Job: TH - Walled Garden Buildings

Title: Door Details - DTB7 P2
Door Type - B8
Sheet 3 of 3

Type: Building 16 & 16a

3124 762.3 P2

03 Door Type B7 - Bottom Rail & Threshold Detail
761.3 SCALE 1:2 @ A1

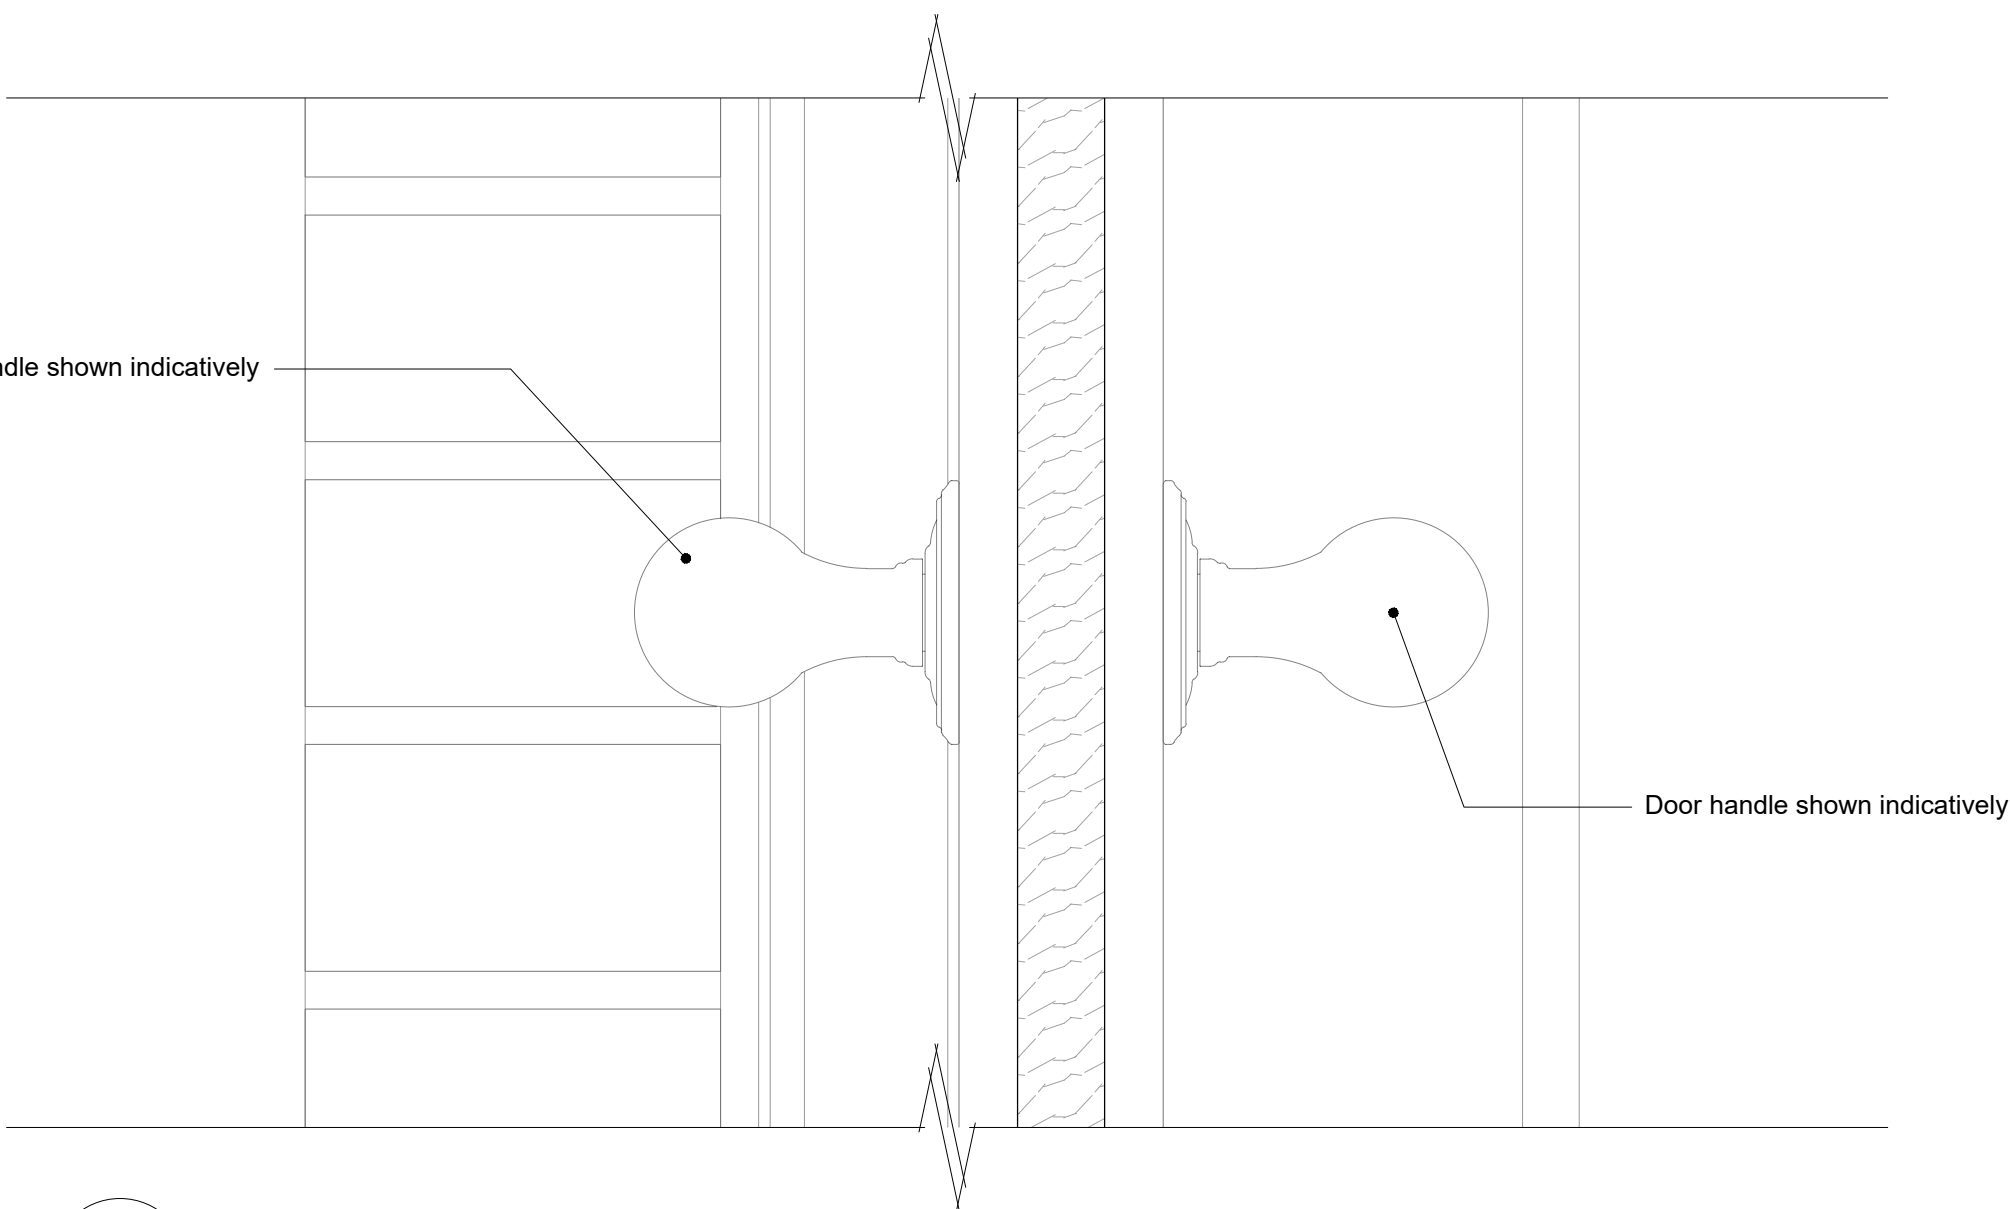
P2 Door amended to traditional timber frame and battened door with a natural stone cill following officers' comments. Scale Bar Amended. 26/03/26
P1 Initial Release dd/mm/yy
